**Addendum No. 1
Erie International Airport
Realignment and Rehabilitation of Taxiway A –
Phase 3**

Project name: <u>of Taxiway A – Phase 3</u>	Client: <u>Erie Regional Airport Authority</u>
Project location: <u>Erie, PA</u>	Client representative: <u>Kimberlie Sharrer</u>
Project number: <u>3225600-192499.05</u>	Mead & Hunt, Inc. Manager: <u>Byron Henicle</u>
Date: <u>May 31, 2024</u>	Mead & Hunt Inc. Phone: <u>971-256-9307</u>

TO ALL BIDDERS: You are requested to make all changes and/or additions contained in this Addendum to the Bidding Documents. Failure to acknowledge this Addendum in Proposal may result in rejection of bid. **THIS ADDENDUM INCLUDES NEW PRICE FORMS. INCLUDE THESE UPDATED FORMS WITH BID.**

E-201

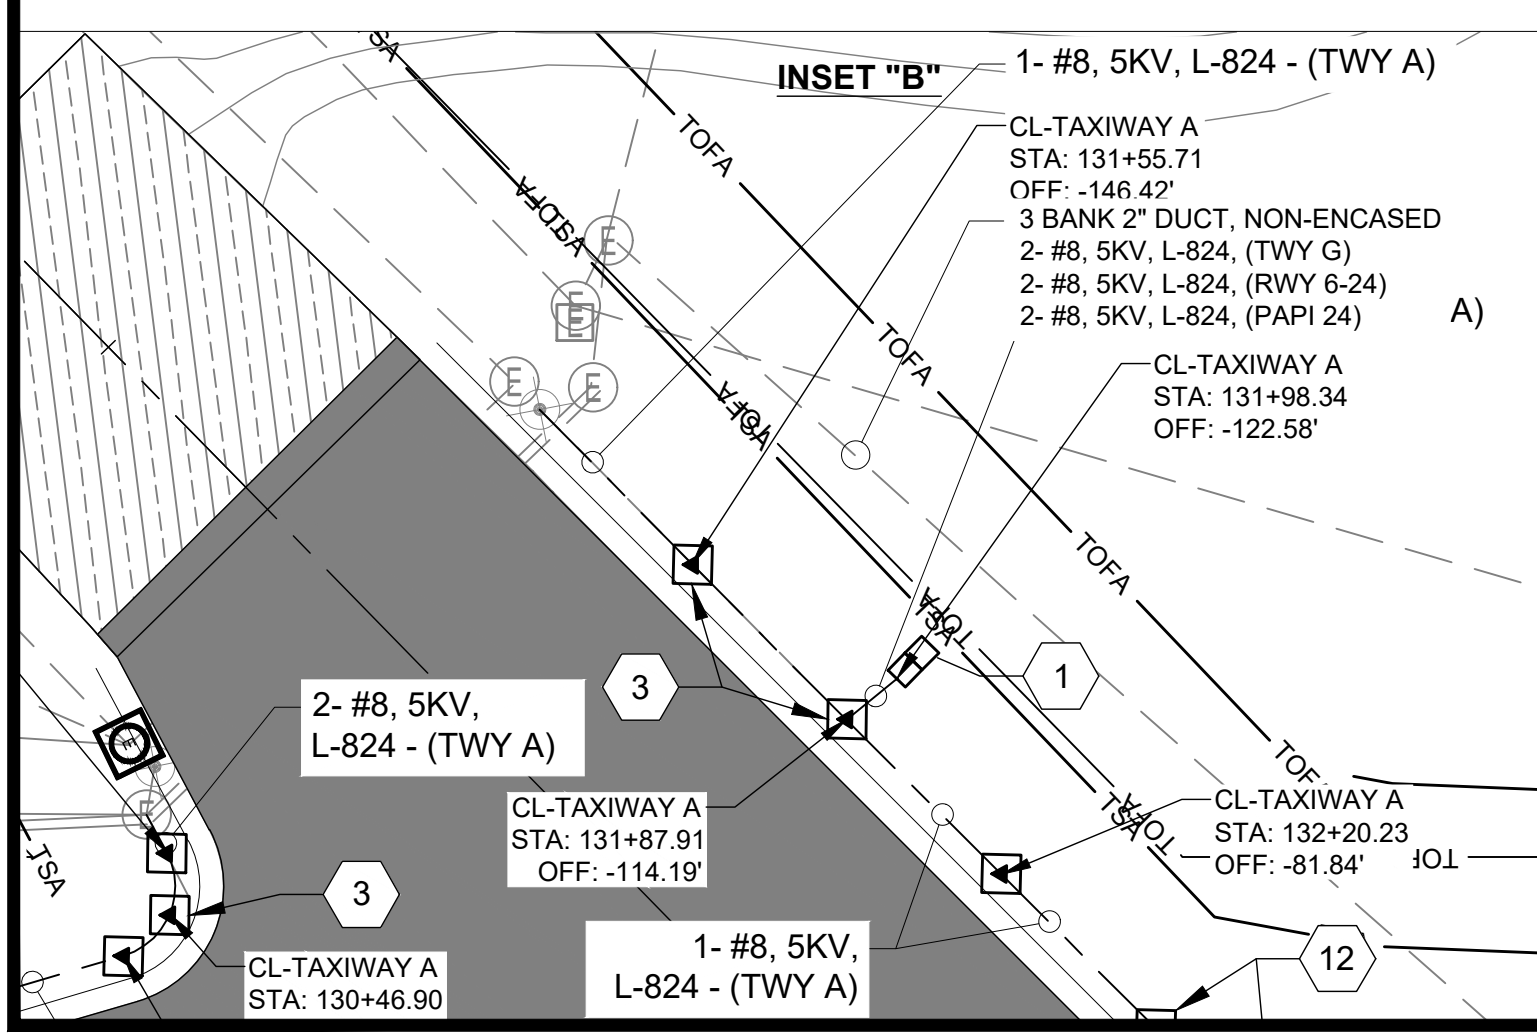
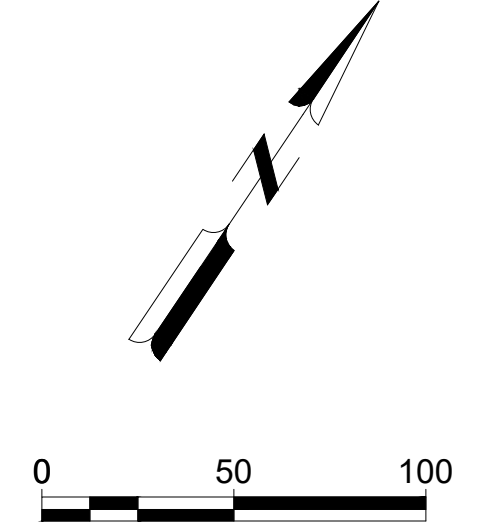
REPLACE Sheets G-003 and E-201. See attached.
